## HISTORIC AND DESIGN REVIEW COMMISSION

**HDRC CASE NO:** 2018-165  
**ADDRESS:** 521 WICKES  
**LEGAL DESCRIPTION:** NCB 2916 BLK 5 LOT 19  
**ZONING:** RM-4, H  
**CITY COUNCIL DIST.:** 1  
**DISTRICT:** King William Historic District  
**APPLICANT:** Amy Tullis  
**OWNER:** Amy Tullis  
**TYPE OF WORK:** Replace existing gravel driveway with concrete patio/driveway; planting of trees and ground plants  
**APPLICATION RECEIVED:** March 27, 2018  
**60-DAY REVIEW:** May 26, 2018  
**REQUEST:**

The applicant is requesting a Certificate of Appropriateness for approval to:

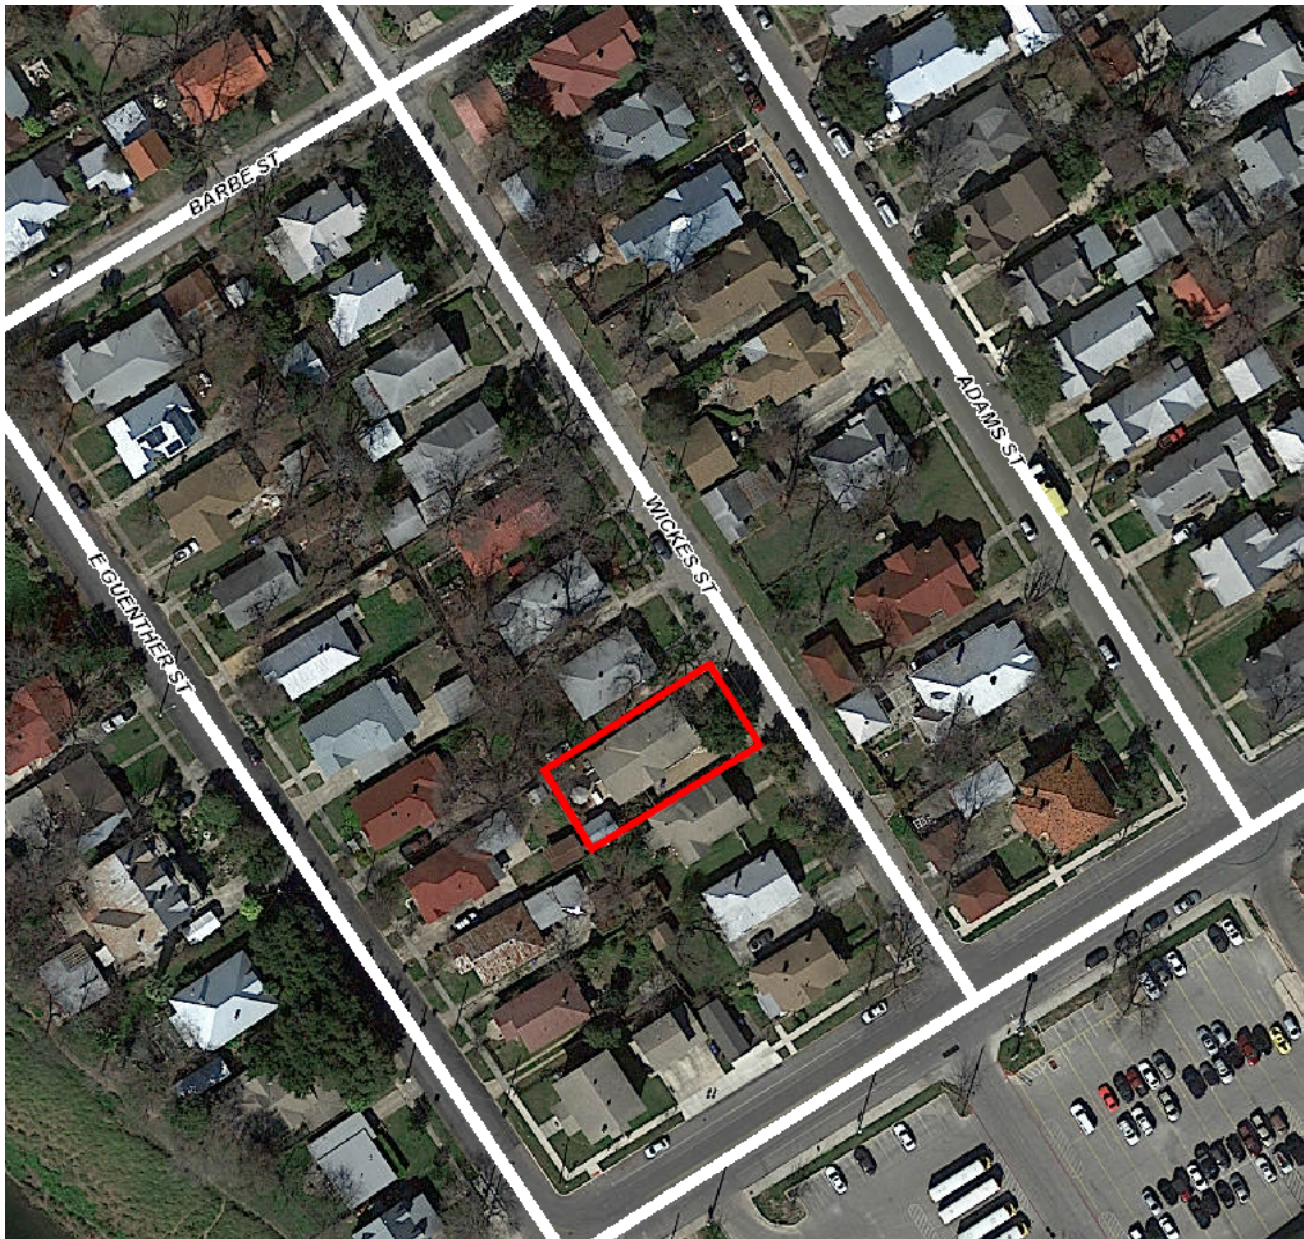
- a. The structure at 521 Wickes was constructed circa 1920 in the Craftsman architectural style. The structure is a one-story, single-family residential structure that features a gable roof, Craftsman brackets and details, a xeriscape lawn and a decomposed granite driveway.

- b. CONCRETE PAD/PATIO – The applicant is requesting to install a 12-foot wide by 24-foot long concrete parking pad (that also functions as a patio) behind the existing privacy fence, at the rear of the driveway and on the side of the home. The Guidelines for Site Elements: Driveways 5.B.i. notes that new driveways should incorporate the configuration, materials, width, and design of driveways historically found on the site or district. The guideline also notes that historic driveways are typically no wider than 10 feet, which is narrower than the proposed 12 feet parking pad. Staff finds that installation of concrete lattice pavers similar to those existing in the front of the driveway would be a more appropriate installation that allows for a functioning patio space while retaining the character-defining features of the site and allowing storm water filtration. Given that the proposed concrete parking pad and patio would not be visible from the public-of-way, staff finds that proposal appropriate.

- c. PLANTINGS – The applicant is requesting to install small crepe myrtle trees and ground plantings behind the driveway privacy gate. Staff finds the proposed plantings consistent with the Guidelines for Landscape Design 3.A.

Staff recommends approval of the concrete parking pad and plantings based on finding b and c.
